Building Permit Application
Howard County Maryland
Department of Inspections, Licenses and Permits
3430 Court House Drive
Permits: 410-313-2455
www.howardcountymd.gov

Date Received: 8-26-14
Permit No.: B14003097

Existing Use: Single family home
Proposed Use: Single family home
Estimated Construction Cost: \$ 125,000
Description of Work: convert garage to office, carport to mudroom, Add basement storage and 1st floor sunroom and 3 car garage.
25' x 16' 26' x 30'
Occupant or Tenant: _____

**RE: B14003097
14022 TRIADELPHIA MILL RD
DAYTON, MD 21036**

SITE PLAN

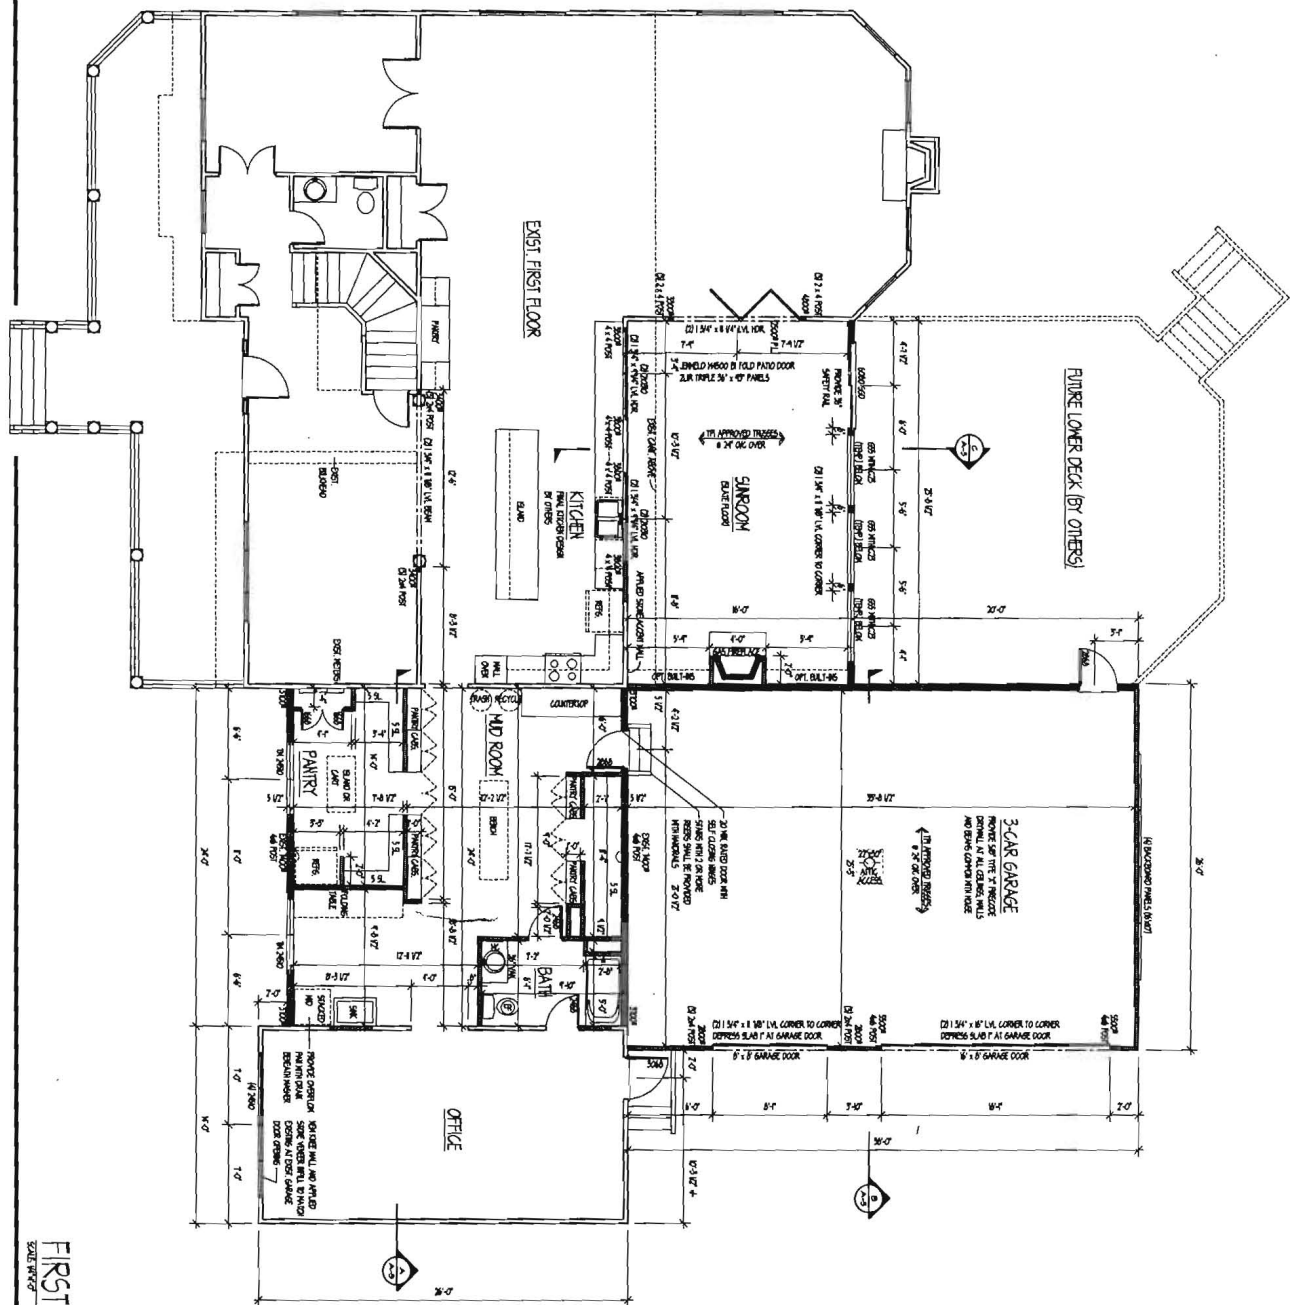
Site plan approved
for 314003097.
9/10/14 -H.O.

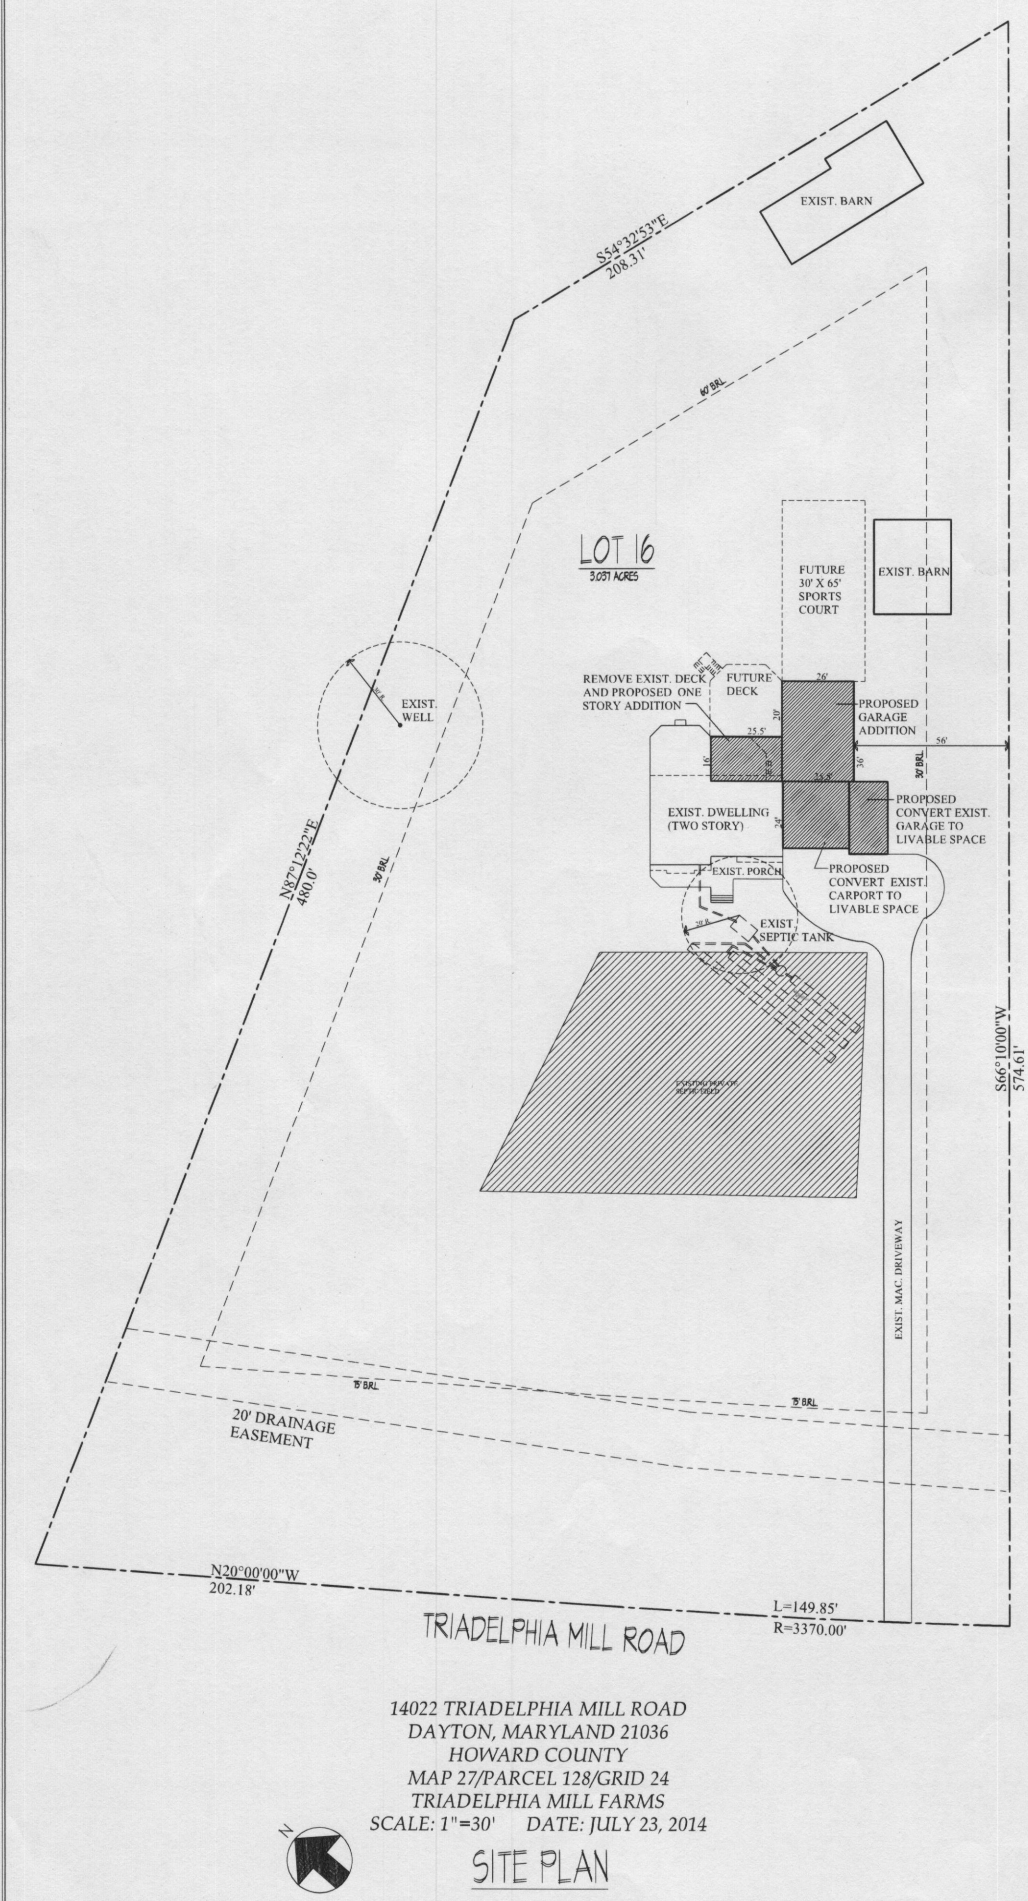
Upon review of the floor plans submitted on 9.8.14, the proposed floor plan layout is actual showing more than 4 bedrooms (by definition under Subtitle 8, Sec. 3.801 (b) Bedroom). The proposed office meets the criteria of a bedroom (please see attached doc regarding definition of a bedroom). Additionally, the septic system on this property is sized for only 4 bedrooms.

At this time, there are (3) options that may be utilized to redefine the proposed office space to a space other than a bedroom;

- 1.) Remove the bathtub in the adjacent bathroom or
- 2.) Make the entrance in to the office a 4 foot wide opening without doors or
- 3.) Build in a permanent book case around the room.

Attached is the updated set of plans showing the 4' opening from the mudroom to the office. Please let me know if you need anything else to proceed. Thank you.
